MIS2020-002 - AMENDED TREE MITIGATION PLAN FOR 3005 N. GOLIAD ST.  
MISCELLANEOUS - LOCATION MAP =

RE: **Tree Removal Application**  
**3005 N. Goliad St**  
**WA # 19022**

**TREE PRESERVATION PLAN**  
 MIXED-USE DEVELOPMENT  
 3005 N. GOLIAD ST  
 ROCKWALL, TEXAS

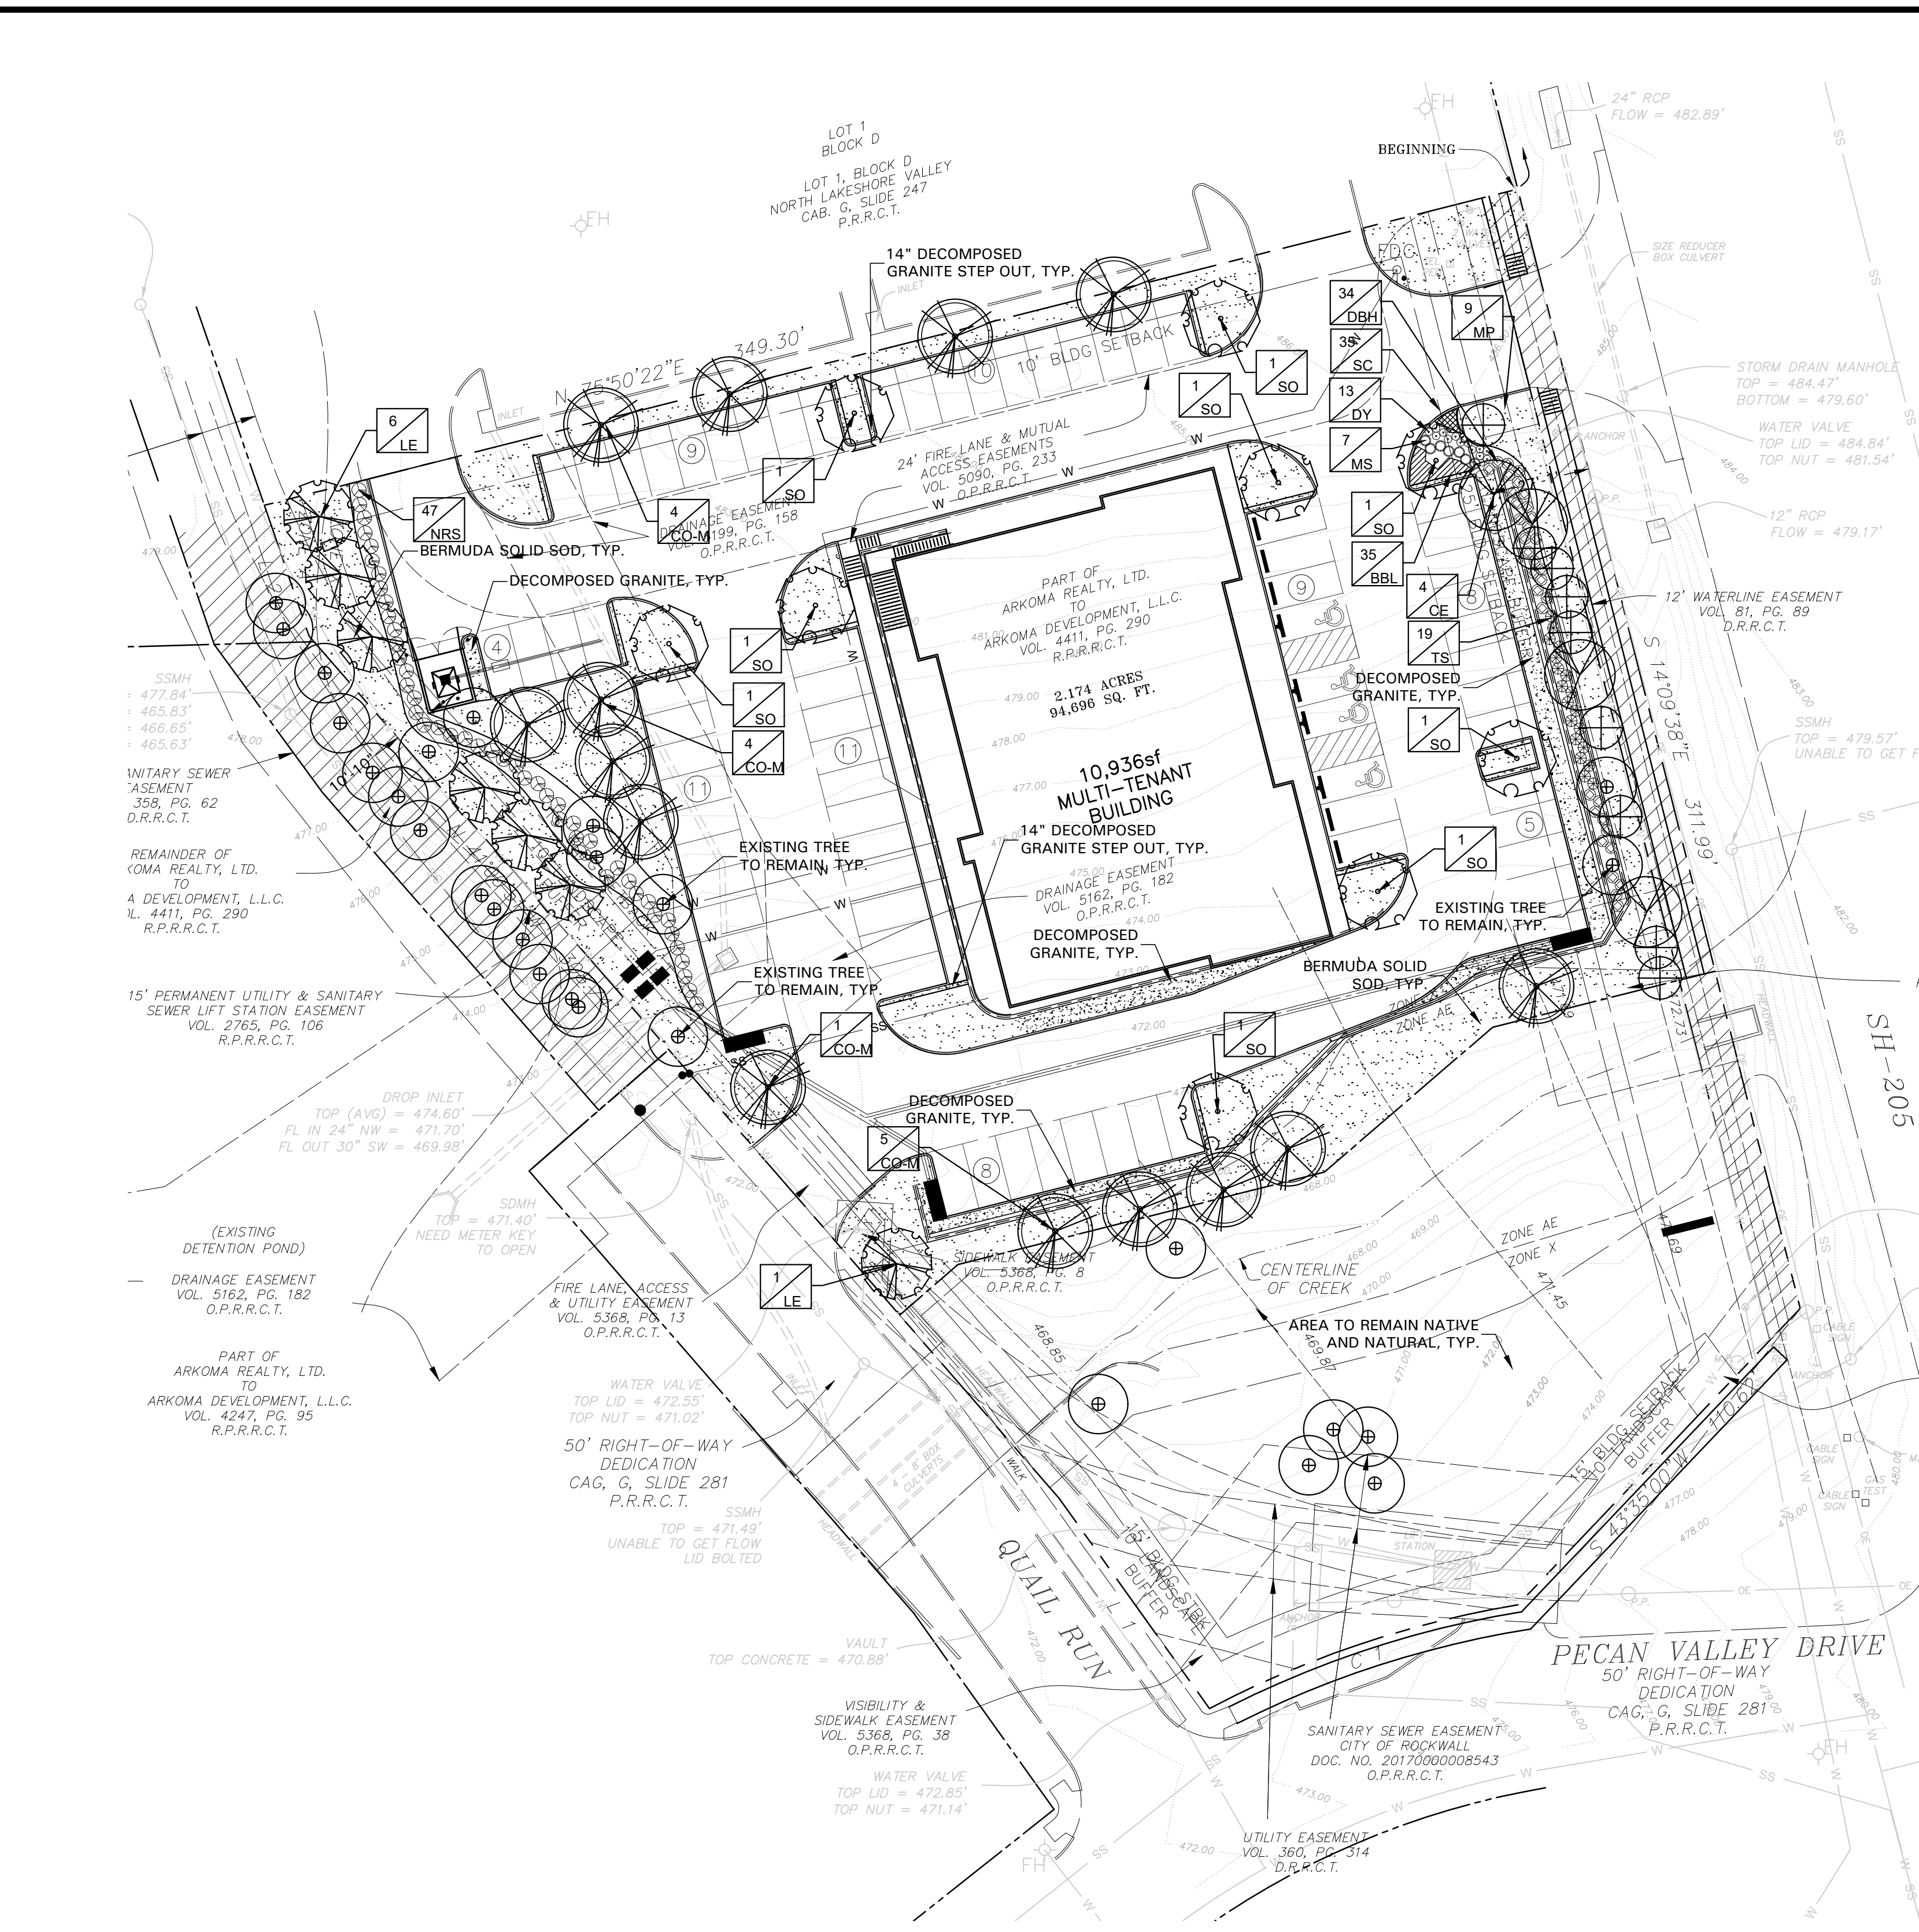
The developer of the property located at 3005 N. Goliad St would like to request the removal of additional trees. The original tree removal and mitigation plan (SP2019-023) was approved by the Planning and Zoning Commission on July 9, 2019 and by City Council on July 15, 2019. The additional protected trees requested to be removed within the property limits include the following (as identified on the attached Tree Preservation Plan):

No.	Caliper	Species
2474	20"	Elm
2561	22"	Pecan
2562	16"	Pecan
2563	24"	Pecan
2564	32"	Pecan*
2596	8"	Pecan
2597	24"	Pecan
2598	29"	Pecan*
2599	24"	Pecan
2701	19"	Pecan
2714	17"	Pecan

Tree numbers 2169, 2607, 2707, 2708, 2709, and 2710 proposed to be removed are located within TxDOT right-of-way and outside of the property limits; therefore, these trees are not counted towards the City's mitigation requirements.
